## IDAP REPORT

<b>Property:</b>	2-4 Badgery Avenue HOMEBUSH Lot: 1 DP:1267936 DA2021.161
<b>Proposal:</b>	Demolition of existing structures and construction of a two (2) storey dwelling with basement, in-ground swimming pool, boundary fencing and associated landscaping.
<b>Applicant:</b>	J Tannous
<b>Owner:</b>	B Wai & A Wai
<b>Date of lodgement:</b>	16 July 2021
<b>Notification period:</b>	23 July 2021 to 9 August 2021
<b>Submissions received:</b>	1
<b>Assessment officer:</b>	G I Choice
<b>Estimated cost of works:</b>	\$1,500,000.00
<b>Zoning:</b>	R2-Low Density Residential - SLEP 2012
<b>Heritage:</b>	No
<b>Flood affected:</b>	No
<b>Is a Clause 4.6 Variation Proposed:</b>	No
<b>RECOMMENDATION OF OFFICER:</b>	<b>APPROVAL</b>

**Figure 18:** Proposed TPZ & SRZ plan

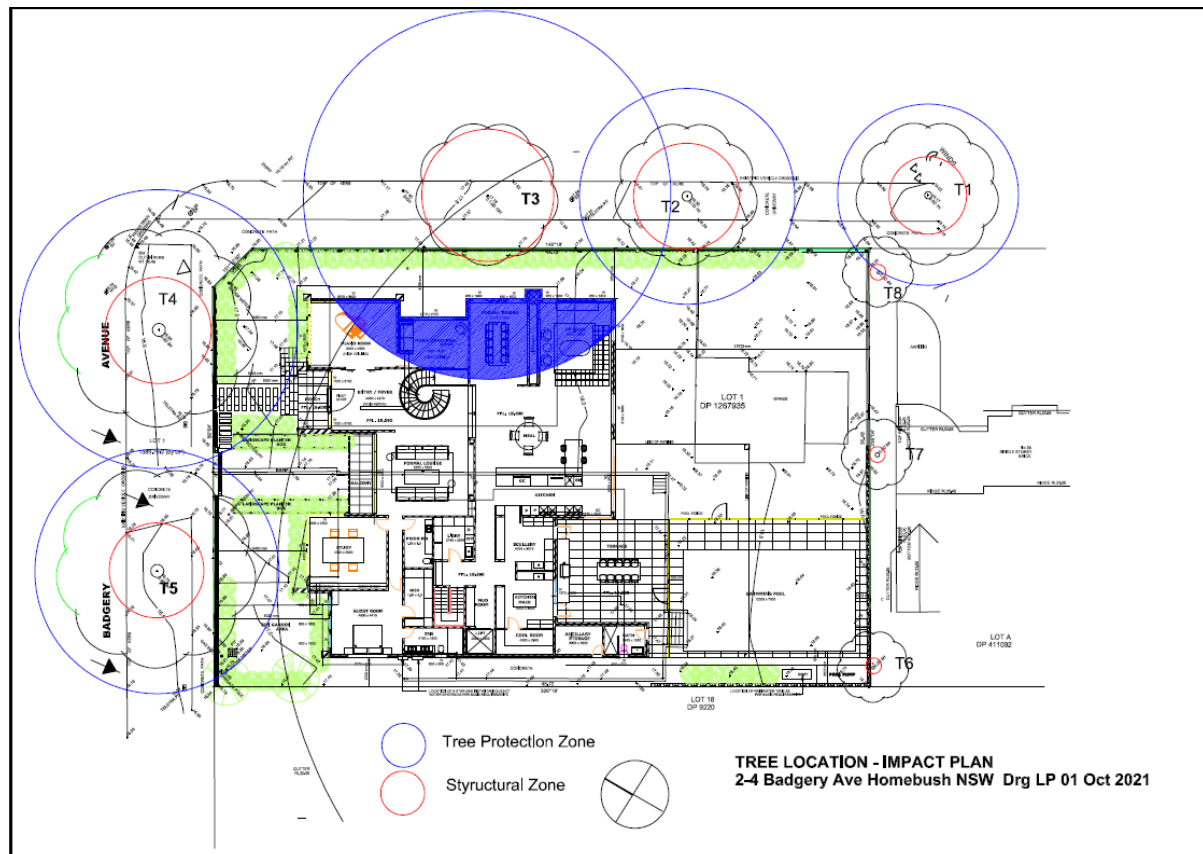
Clauses 4 and 5 of Part O provide detailed controls regarding tree management, protection and removal. With regard to tree management for the proposed development, there are eight (8) trees – located within and adjacent the subject site - that are relevant to this proposed development as shown in **Figure 18** and described in the table below:

The submitted *Tree Assessment & Protection* report prepared by *Stuart Pittendrigh* (dated 29 October 2021) has been reviewed by Council's Tree Management Coordinator (TMC). The TMC supports the proposal and has imposed a number of conditions to ensure the retention and protection of significant trees including a tree bond and specific construction techniques for the front fence piers.

- (k) To preserve the Trees 1, 2, 3, 4 & 5 as marked on Tree Location- Impact Plan DRG LP 01 Oct 2021 prepared by Stuart Pittendrigh dated October 2021, the footings of the proposed front brick fence shall be isolated pier and beam construction within a 4 metre radius of the trunk. The piers shall be hand dug and located such that no roots of a diameter greater than 50mm are severed or injured in the process of any site works during the construction period. The beam shall be located on or above the existing soil levels.
